City of Ryde Submission

6 Halifax Street Macquarie Park

SSD-65931214: Affordable Housing

Submission Date: 17 May 2024

Figure 4: Extract from Lachlan's Line Urban Design Guide

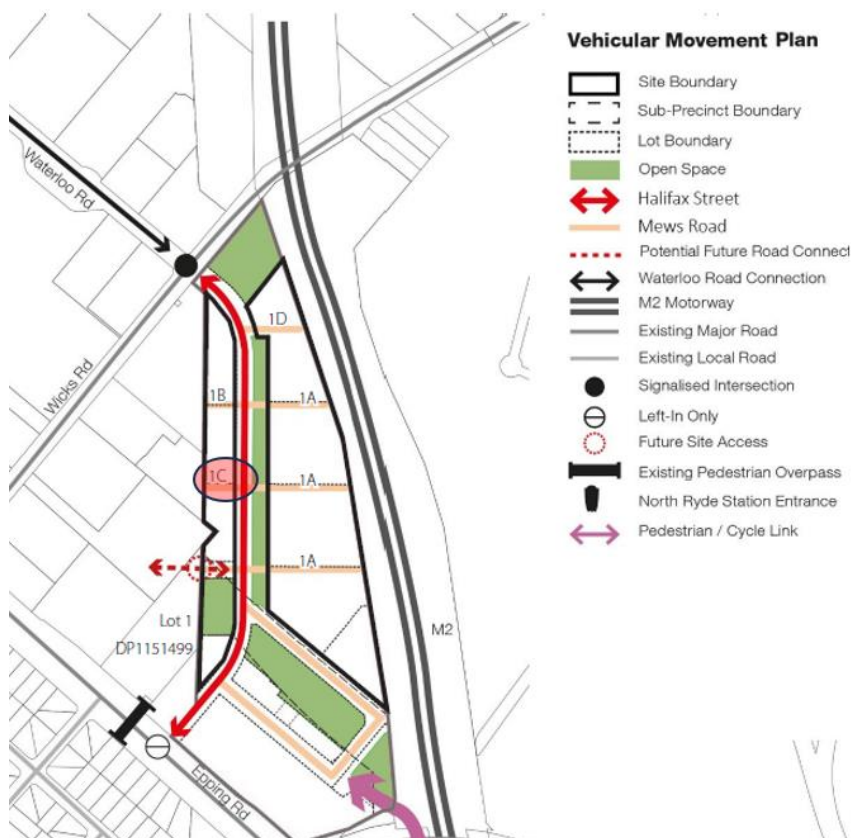
Figure 4 below details new Mews Roads to be delivered on private property to enable adequate vehicular and pedestrian access to the site. At the Northern extent of the site a Mews Road categorised as '1C' will be required. Figure 5 shows the detail for new mews roads classified as '1C', showing required carriageway and footpath widths.

The detail shows that a 6.0m carriageway, 5.5m parking bay, 3.0m footpath (1.5m of this within the subject lot boundary) on the northern side of the mews road and a 2.0m width footpath on the southern side along with a 2.0m landscape strip. This adds up to a total width of a 17.0m width mews road. The proposed development does not provide a Mews Road arrangement consistent with the required controls, which Council does not support.

Figure 6: Extract from submitted plans demonstrating the building encroaching the easement

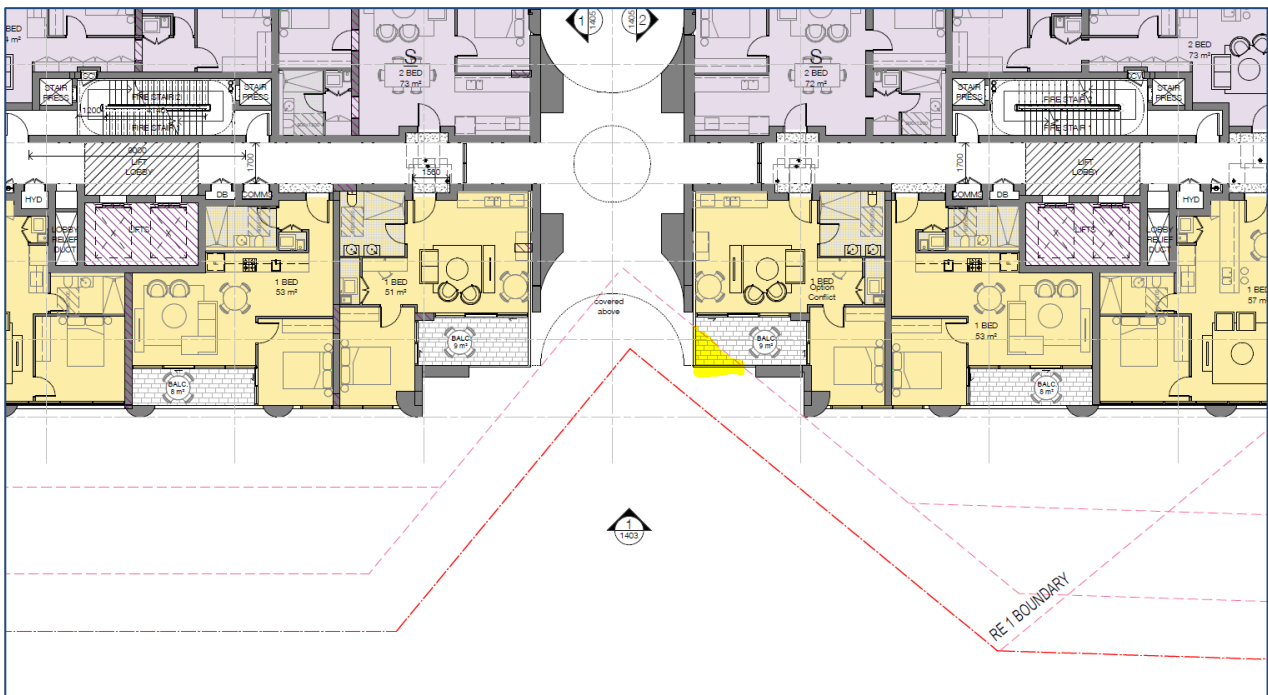
- Full electronic copies of executable TUFLOW modelling file compatible with QGIS software (including batch file for run and flood difference file) clearly identifying each scenario shall be submitted to Council for further assessment. Electronic copy of modelling results for pre and post development scenario for velocity, depth, flood level, VxD and VxD afflux, flood level afflux for 1% AEP and PMF in .asc format shall be submitted.
- The submitted Architectural plans are to be modified to avoid any encroachment to the easement (see Figure 6 below), including eaves, gutters, window aluminium decorations, balcony, roof, etc. the proposed development is encroaching the easement throughout its design as shown in the below figures:

Figure 7: Extract from submitted plans demonstrating the building encroaching the easement

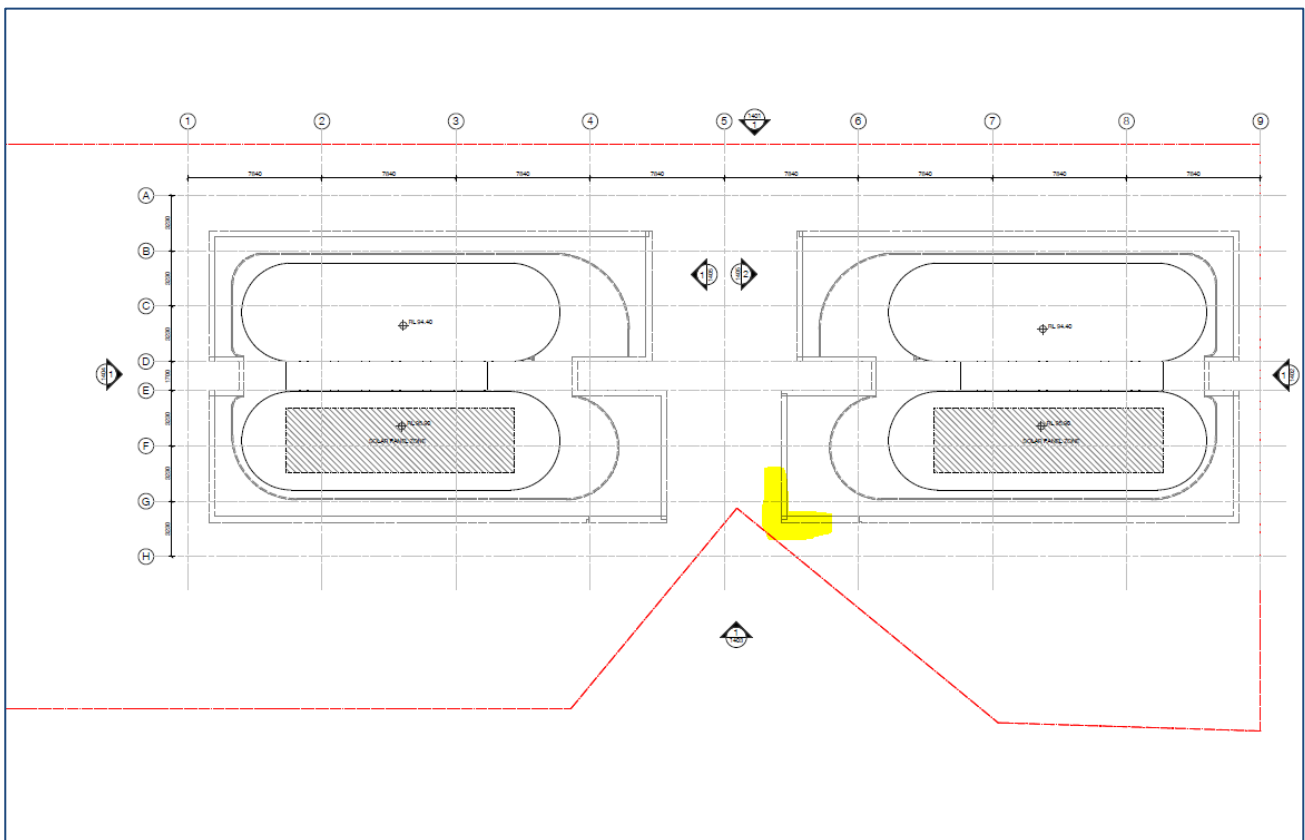
- Please indicate the horizontal clearance from the proposed development to the existing Council stormwater pipe. The proposed development to be minimum 1m away from the **outermost part** of the existing Council stormwater pipes.

Figure 8: Ryde Council's Stormwater Asset

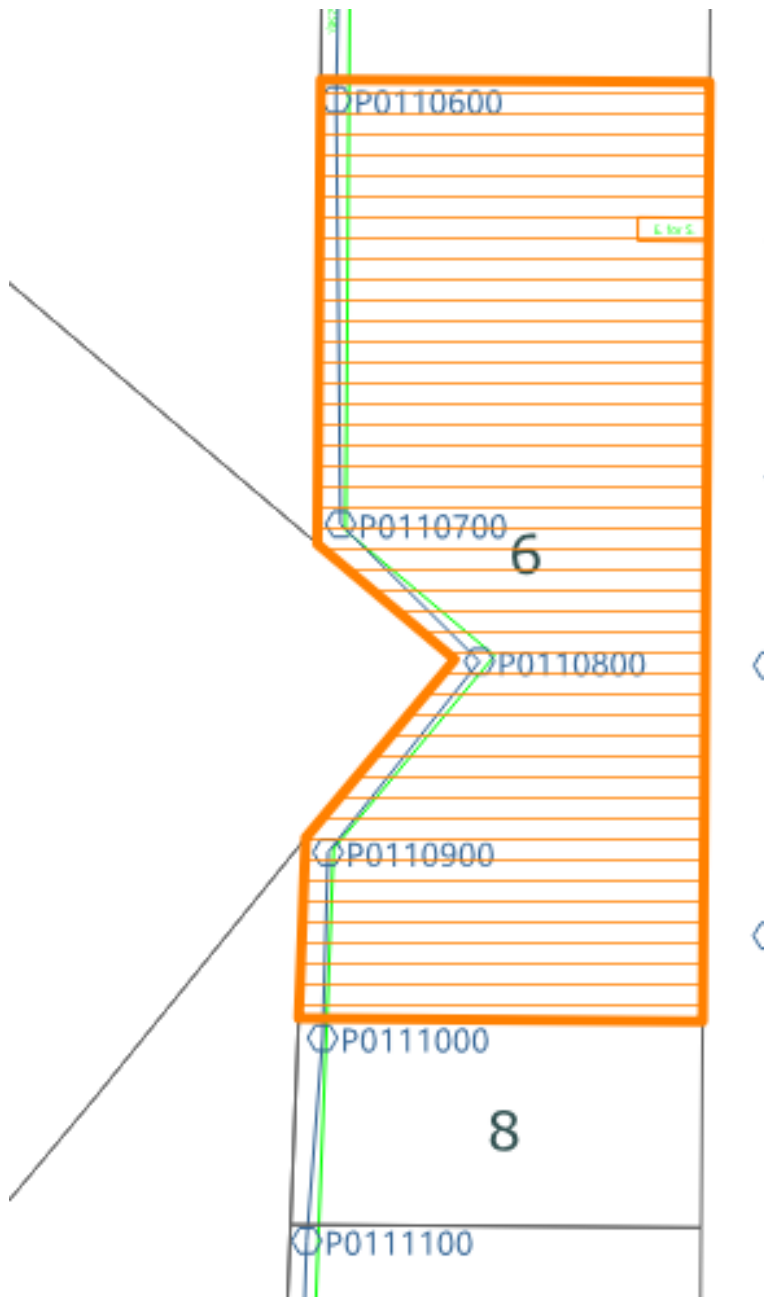
- Please indicate the existing Council **pipe and pits** on the Architectural and Civil plans. Pipe to be indicated to scale. Please see Council stormwater diagram below for your reference:

Figure 9: Figure demonstrating appropriate footings

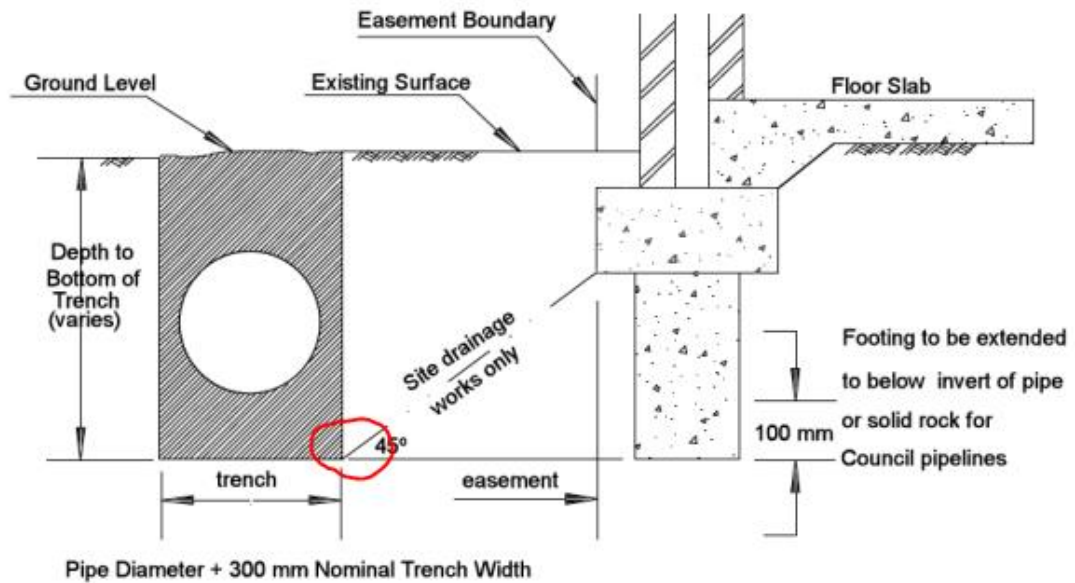
- The proposed development is located adjacent to the Council's drainage system, please demonstrate that the footing of the proposed structure is below the adjacent invert levels of the Council's drainage system and no loading is placed on Council's drainage system.
- Structural plans to be prepared by qualified structural engineer including the footings and foundations of all proposed structures adjacent to the existing Council. Please refer below for your reference:

Figure 10: Mark up of submitted plans

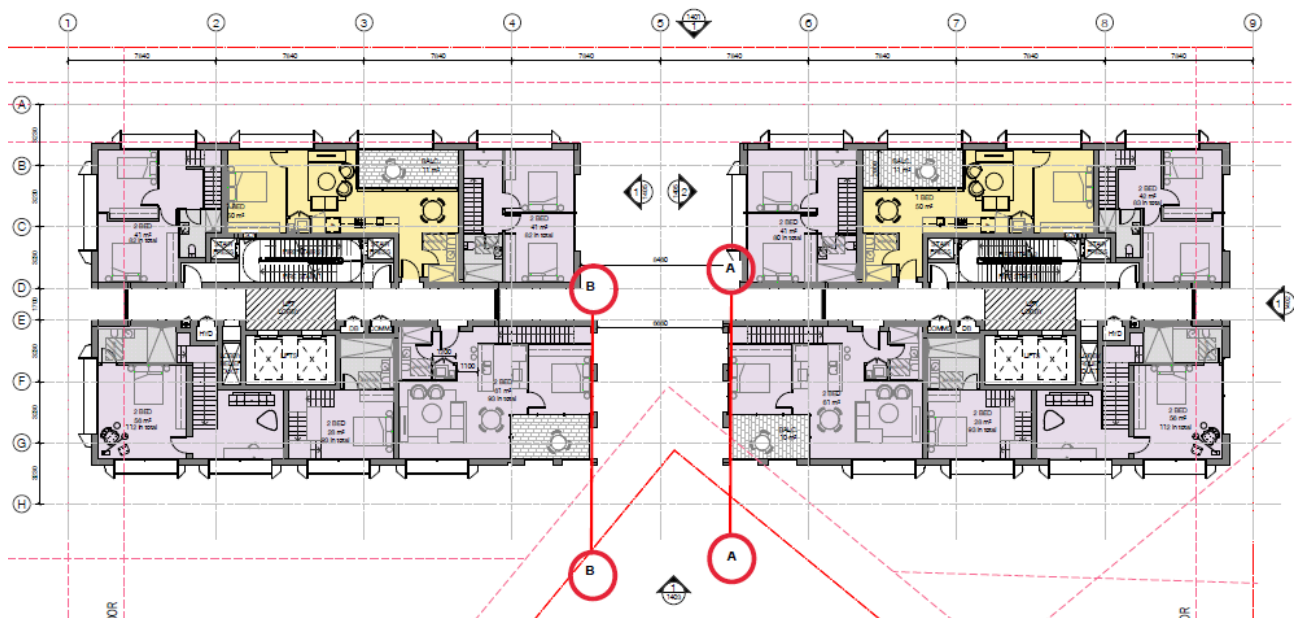
- Please indicate the easement boundary, the development footings/piers and the stormwater pipe at the sections close to Council easement. Please extend the cross section as below:
